PROPOSED AMENDMENT DRAWING

NO.1 TRITON SQUARE

NMA DESIGN REPORT

246868-A_A-XX-XX-DR-AX-30540

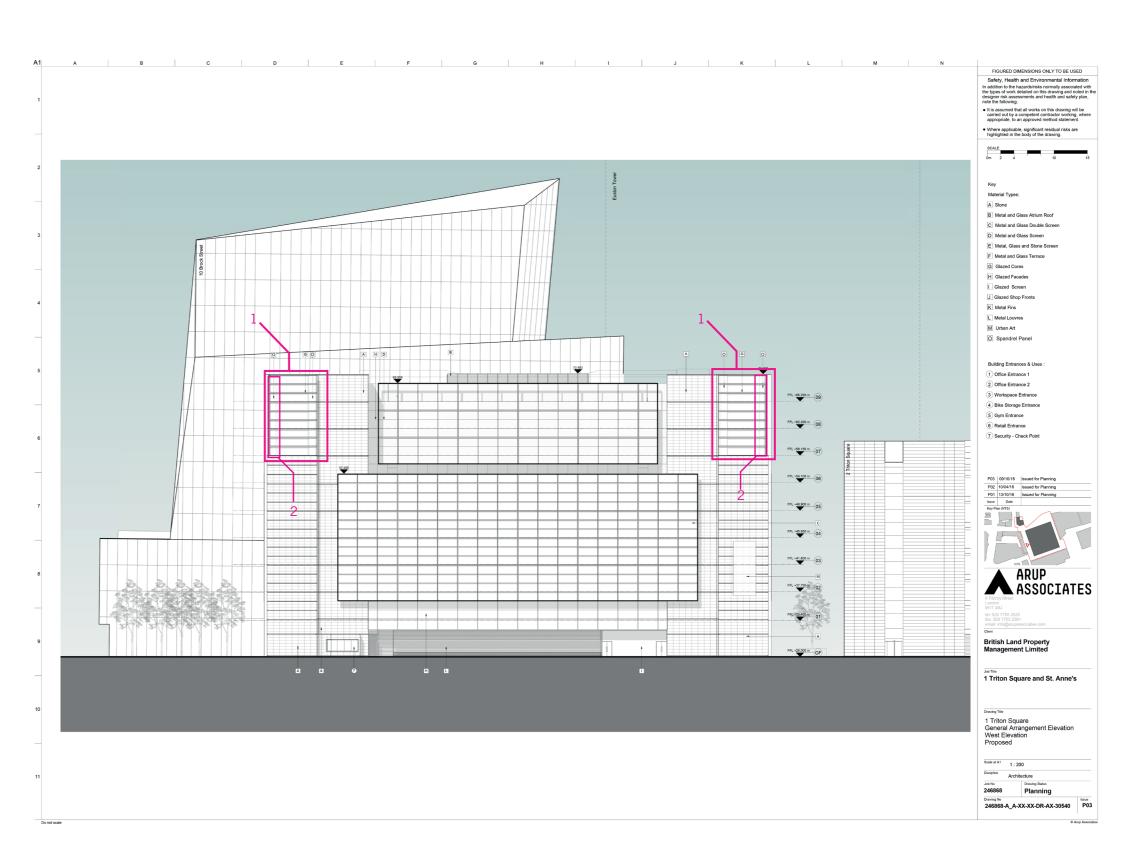
- (1) A change in materials to the transoms at the top of cores from stone to anodised aluminium is proposed. Each transom is 7m wide and following design development deemed structurally unachievable given weight and aesthetic requirement for unobstructed panoramic glazing panels. This affects 6 of the 10 transoms at the top of each core. The remaining 4 are natural anodised aluminium as approved.
- (2) Introduction of additional mullion to separate back painted glass spandrel panel from vision glazing note spandrel panel hides steel column behind.

246868-A_A-XX-XX-DR-AX-36704 Facade Detail - Core Extensions

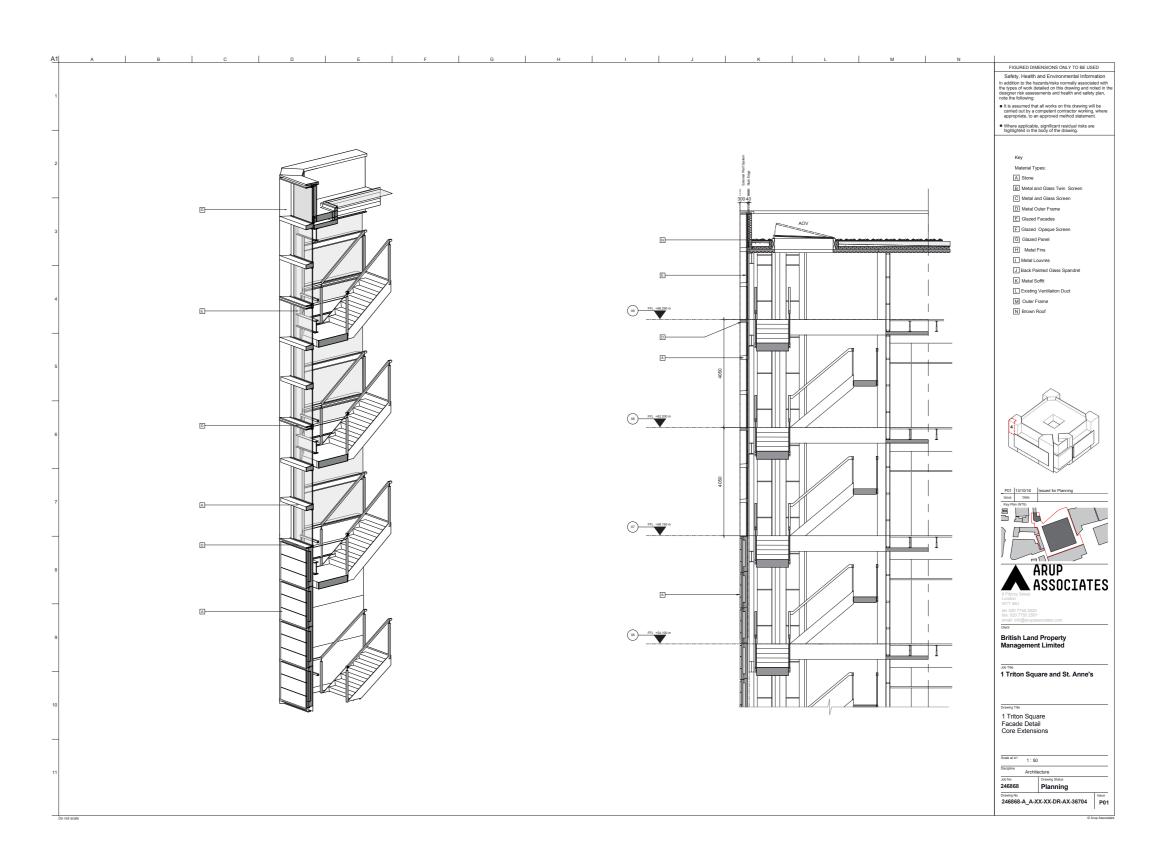
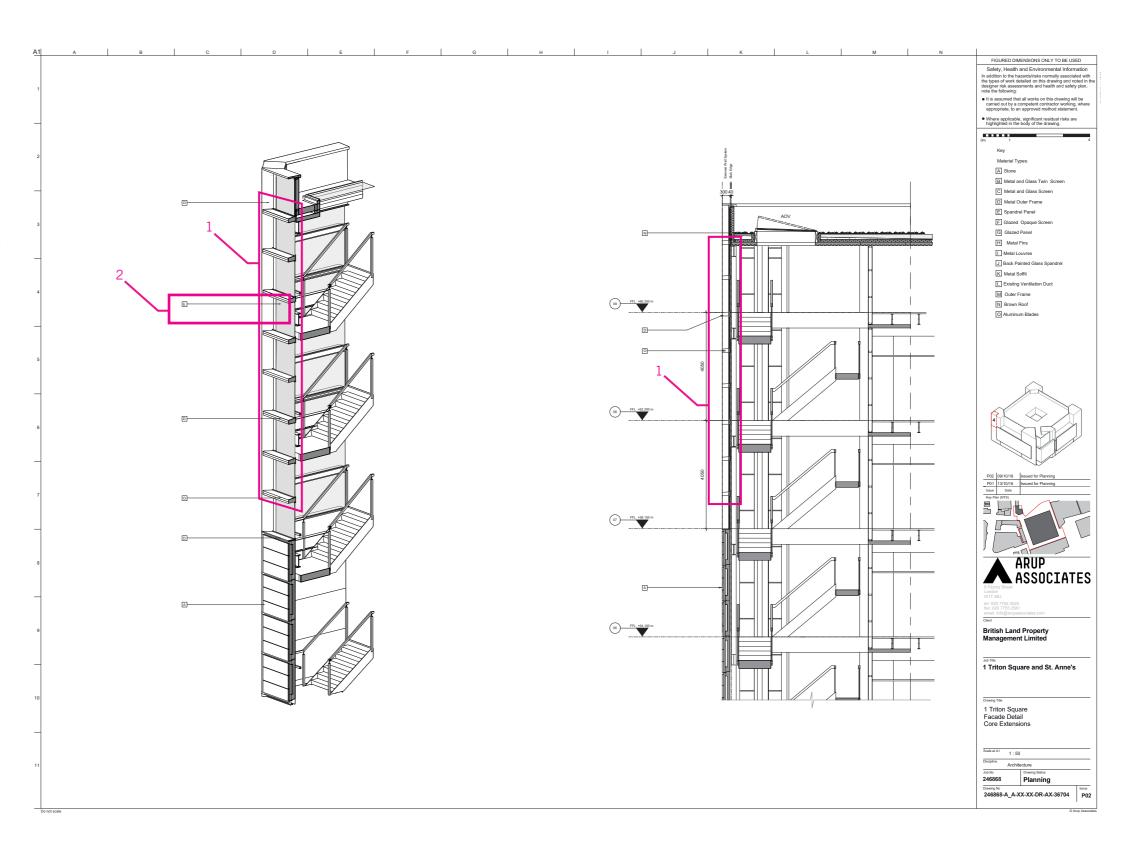
- (1) A change in materials to the transoms at the top of cores from stone to anodised aluminium is proposed. Each transom is 7m wide and following design development deemed structurally unachievable given weight and aesthetic requirement for unobstructed panoramic glazing panels. This affects 6 of the 10 transoms at the top of each core. The remaining 4 are natural anodised aluminium as approved.
- (2) Introduction of additional mullion to separate back painted glass spandrel panel from vision glazing note spandrel panel hides steel column behind.
